January 15, 1996

Subject: Cricket Mountain Project (SRK#57705) - Response to UDOGM Comments on Notice of Intent to Revise Existing Large Mining Operation (M/027/006)

Continental Lime, Inc
Cricket Mountain Project
Typical Facility Cross-Sections

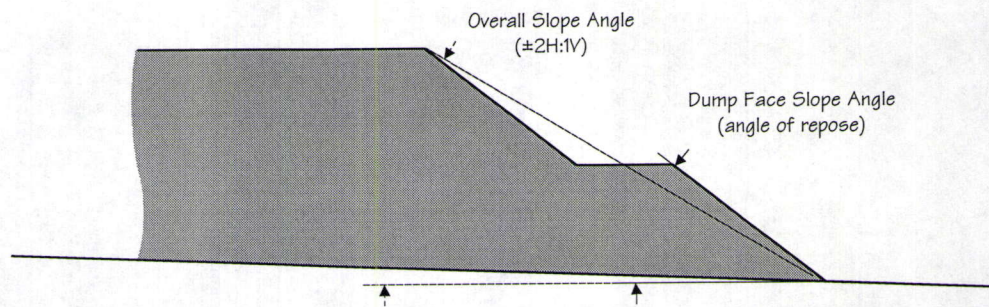
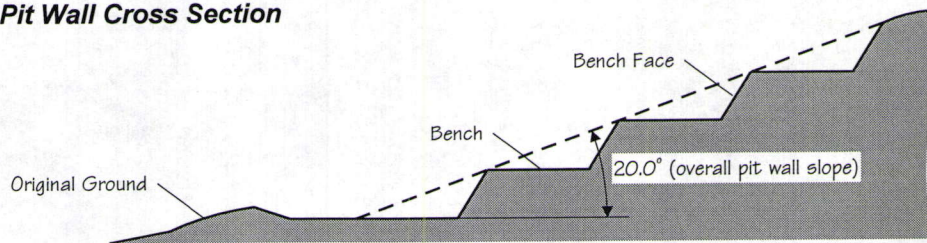
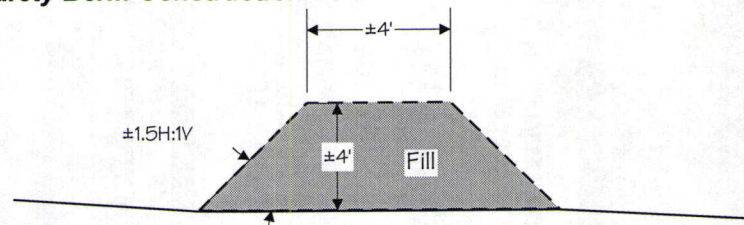
105.3 Drawings or Cross Sections (slopes, roads, pad, etc.)

Signs restricting access to the site would be placed around the site; and access to the highwall areas would be restricted by physical barriers such as but not limited to rock berms. Rock berms would be constructed of available quarry reject material(s). The berms will be of sufficient size and quantity to reasonably restrict vehicular travel into the site during operations and post-closure.

The attached figures depicts the cross-sectional configurations of the waste rock dumps, pit highwall and pit highwall safety berms. The use of boulders as an alternative method barricading the highwall was discussed, and agreed upon, in our November 20th meeting. If boulders were used they would be of a size which would preclude removal (typically ≥ 4 ft) and a spacing which would restrict vehicle access (typically ≤ 4 ft).

Continental Lime, Inc
Cricket Mountain Project
Typical Quarry Cross-Section

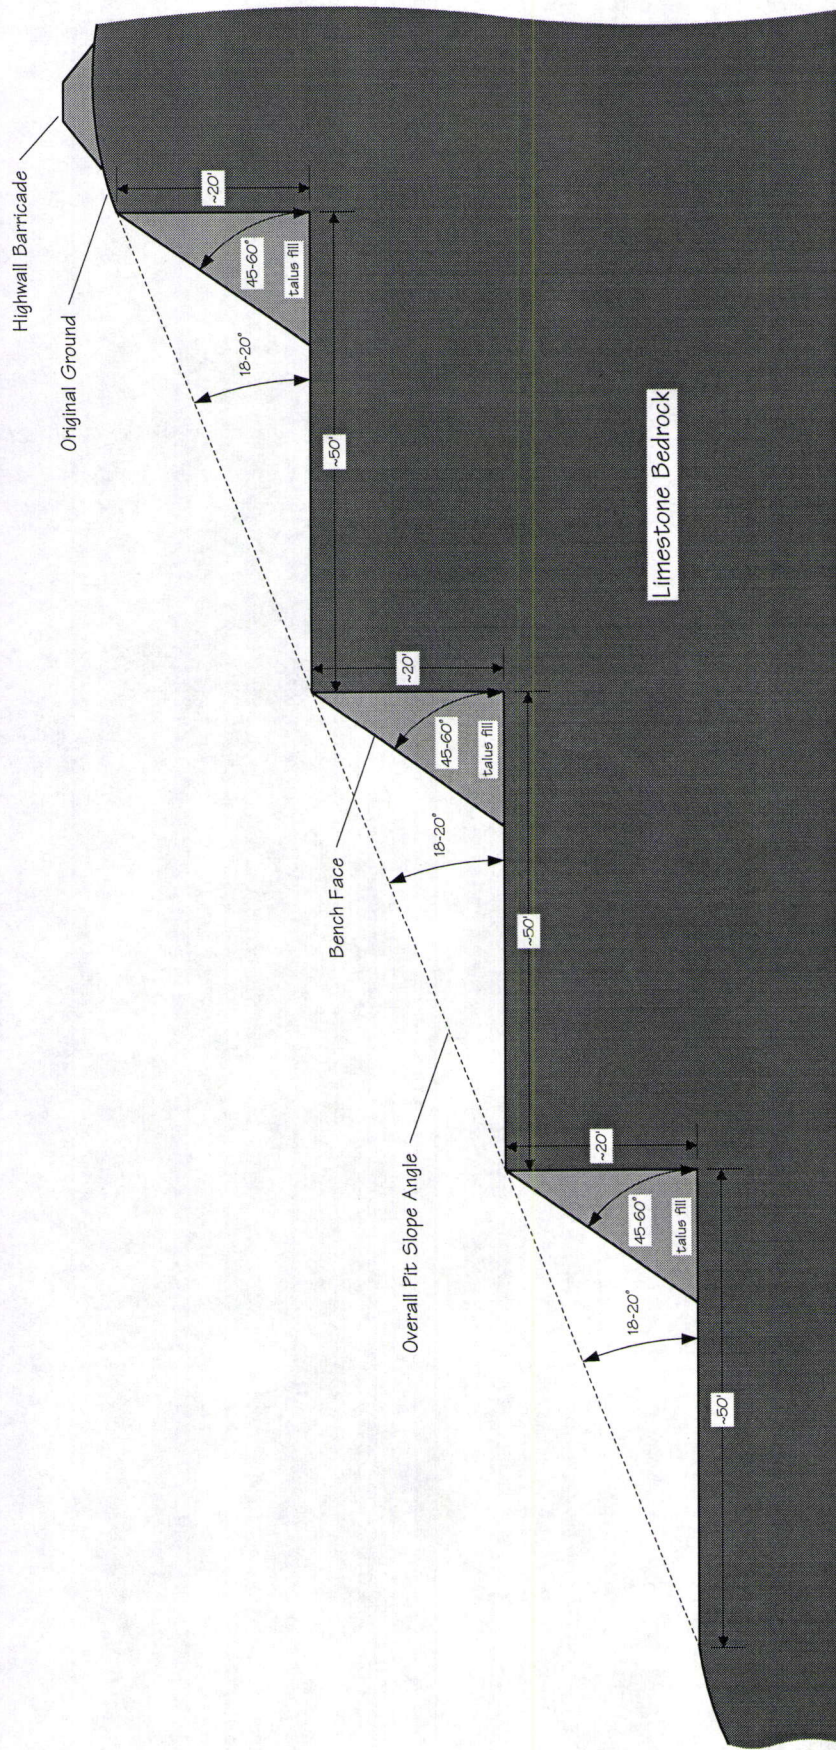
106.2 Type of operations conducted, mining method, processing etc.

The quarry walls will be developed parallel to the dip of the limestone beds with an overall slope of approximately 20°. The individual benches will be approximately 20 feet high and 50 to 60 feet wide. The initial inter-bench slope faces will be near vertical with slopes flattening over time through the natural development of talus fill to approximately 45 to 70° (see attached Figure B). This configuration will not produce high, long, steep slopes for the highwalls, but rather a more gentle stair-step configuration. This configuration, along with the proposed highwall barricade structures, will substantially limit the possible safety risks.

The physical dimensions of the pit highwall are also described in Section 3.3 of the NOI. Please refer to the attached figures.
